## McClellan Air Force Base

Basewide Groundwater Operable Unit

# Groundwater Operable Unit Remedial Investigation/ Feasibility Study Report

**SUBJECT:** Groundwater (GW) Operable Unit (OU) Final Remedial Investigation/Feasibility Study (RI/FS) Document

MEY94/MEY-E-8.dgn

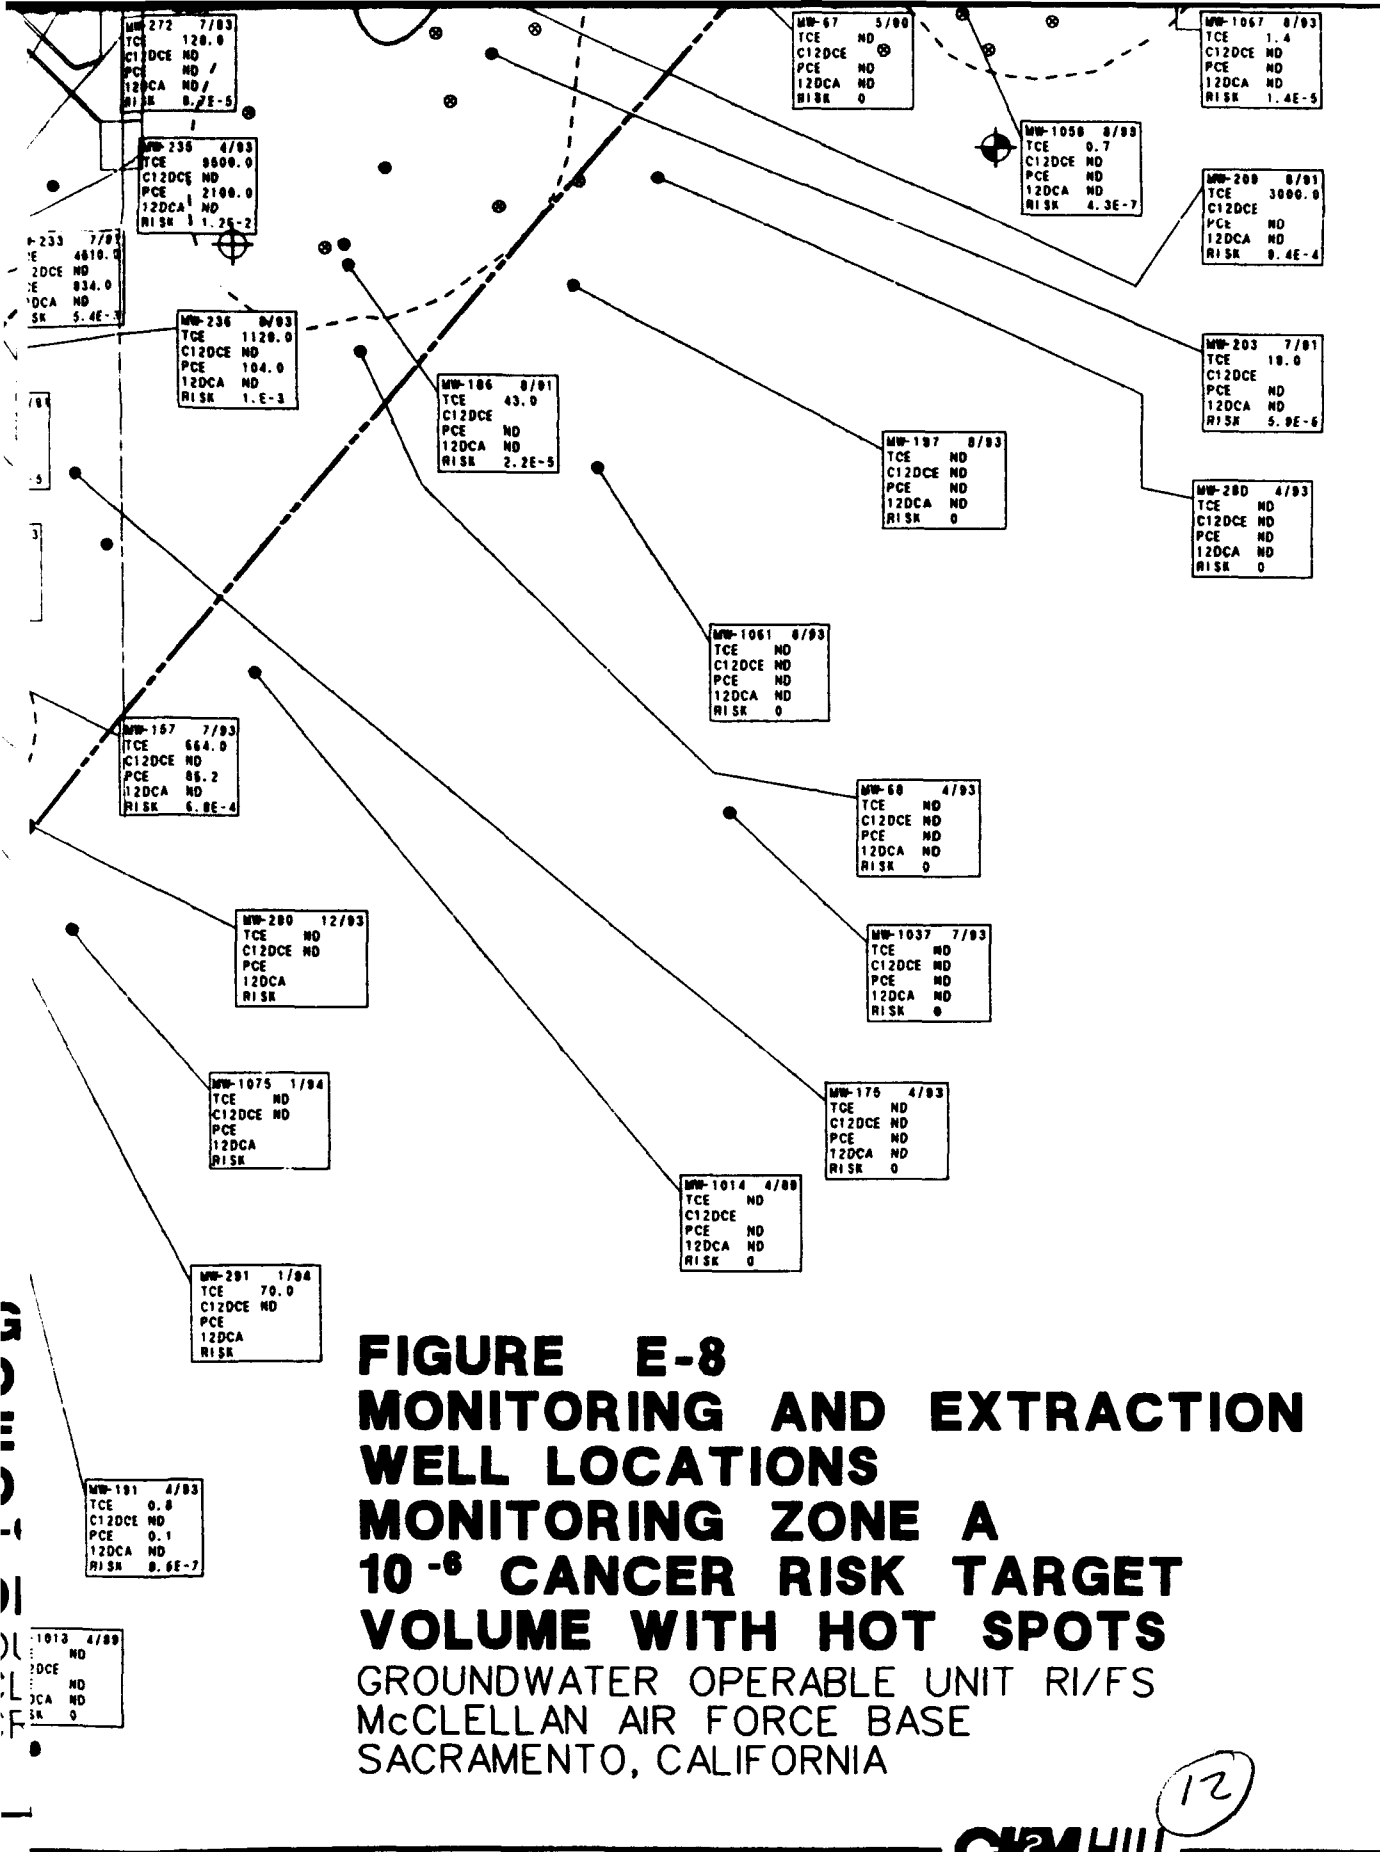
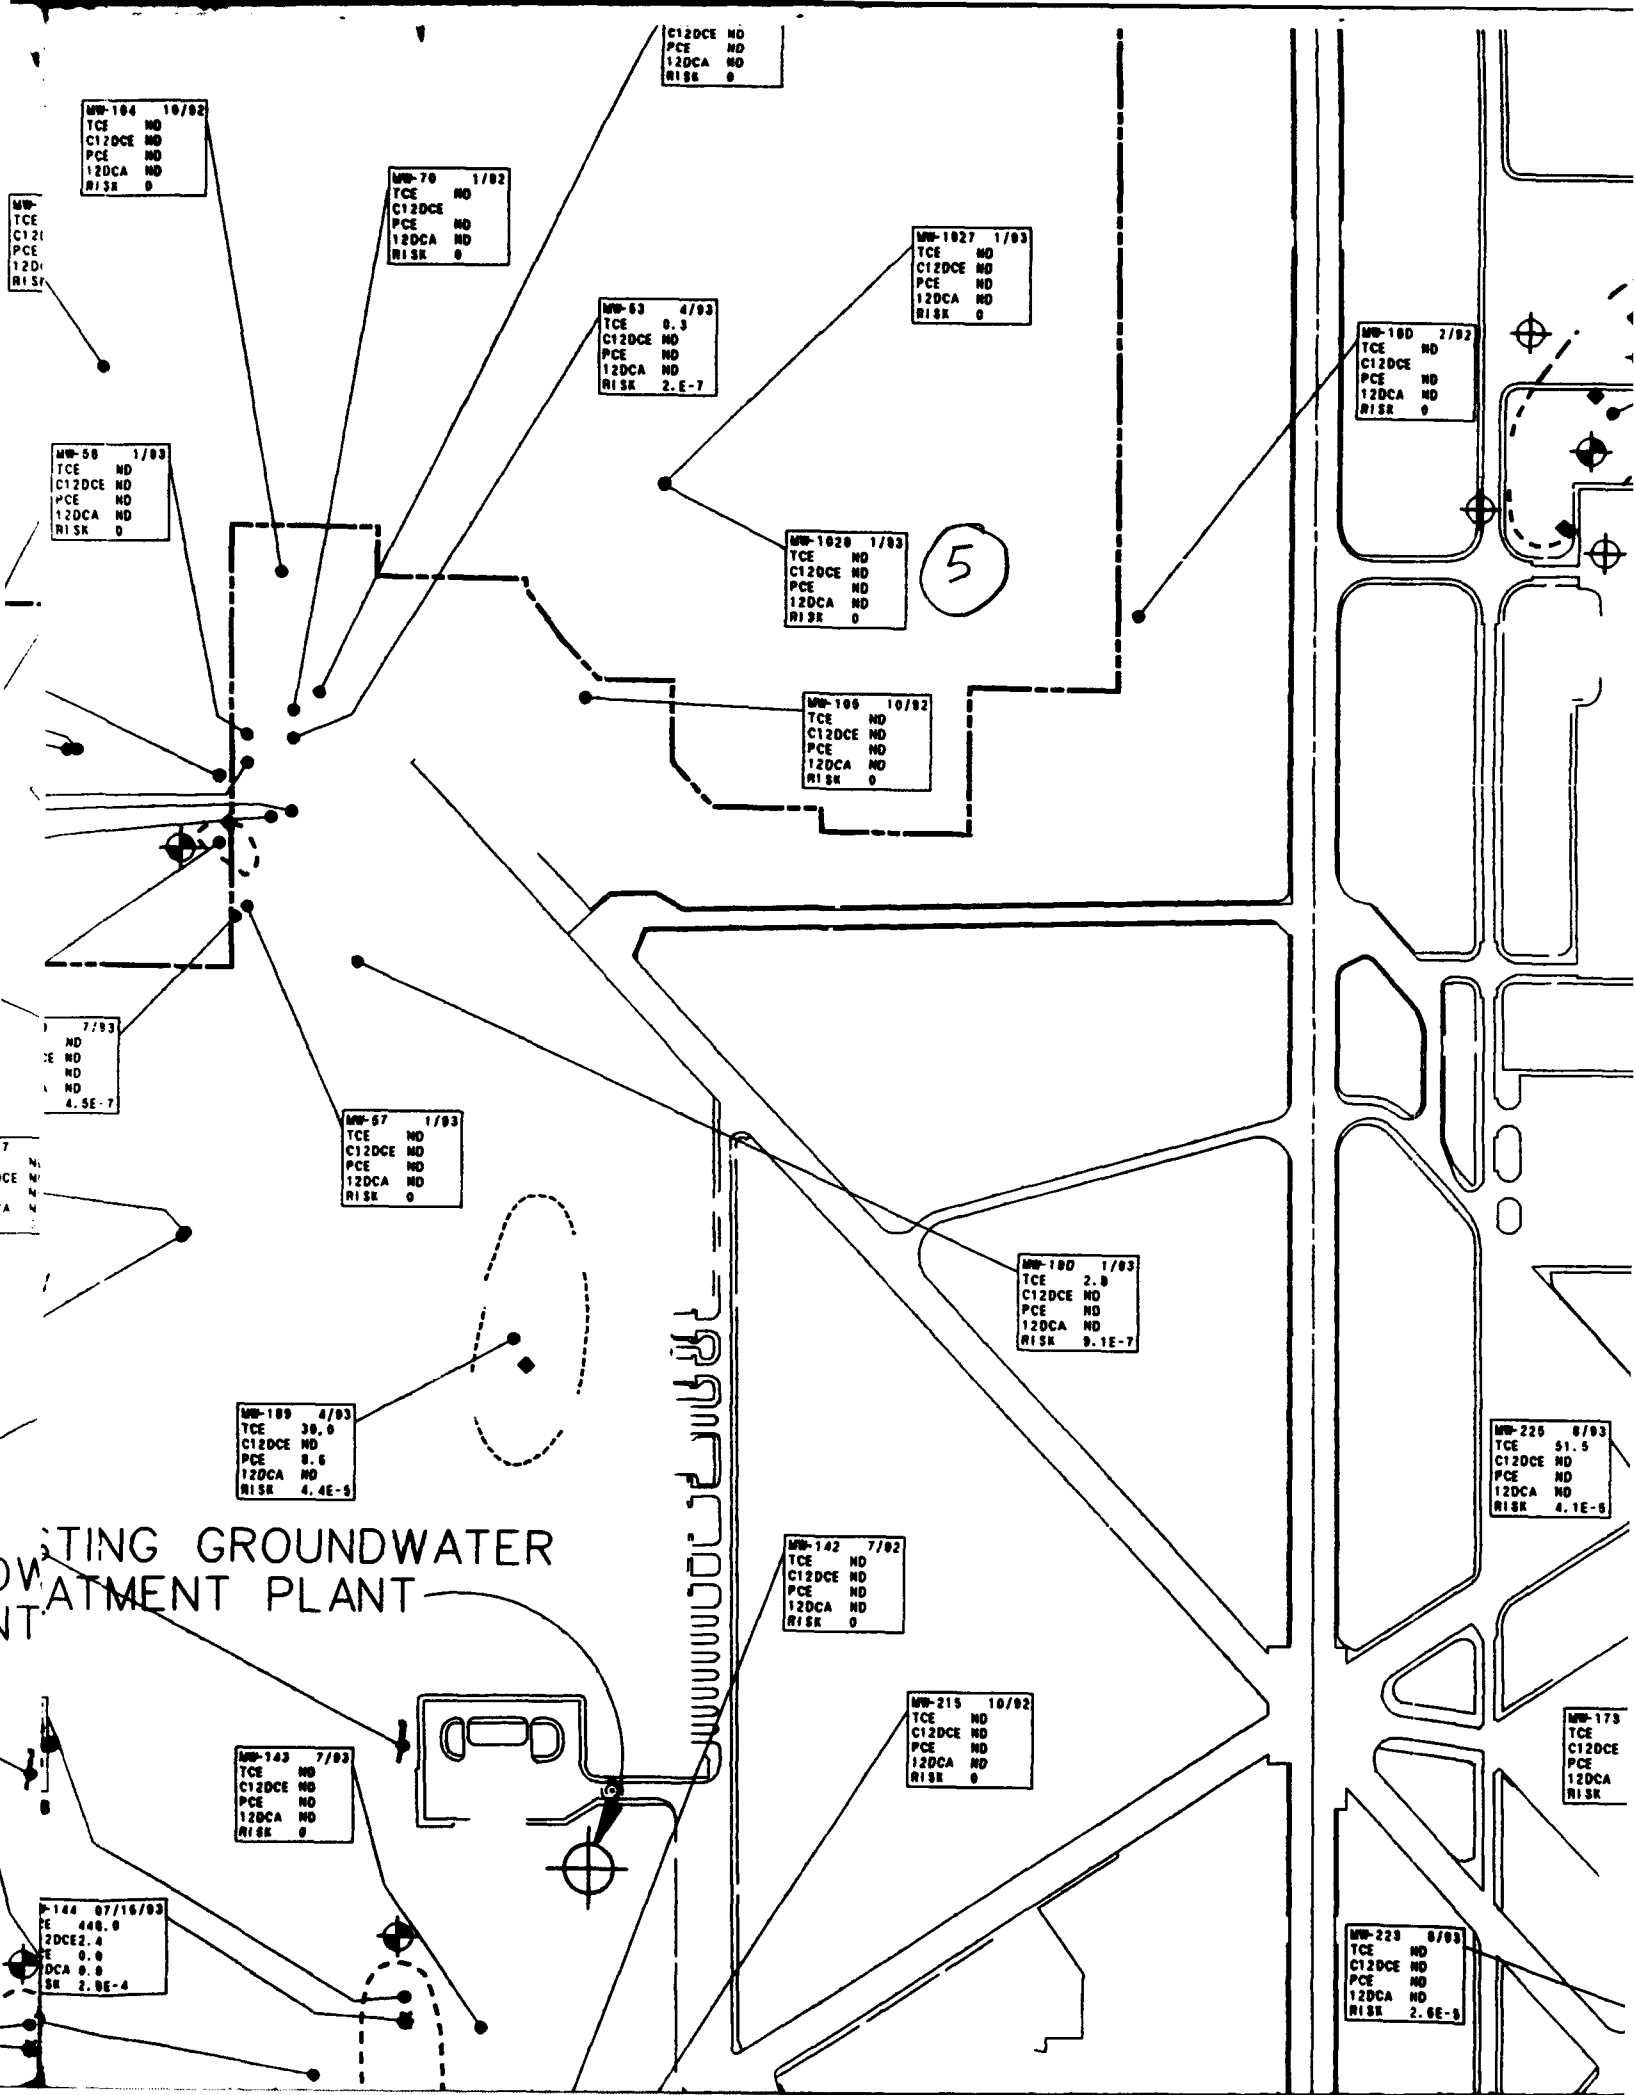
**Figures E-8 and E-9. The text described the need to monitor between the A and B zones in OU-C. Neither figure proposes additional wells suggested by the text. The figures do not indicate additional wells to further define the plume emanating from OU-C1 in the B zone. The maps do not identify the OU-B EE/CA wells, or indicate the need for extraction wells around the OU-B base perimeter to prevent off-base migration when BW-18 is decommissioned.**
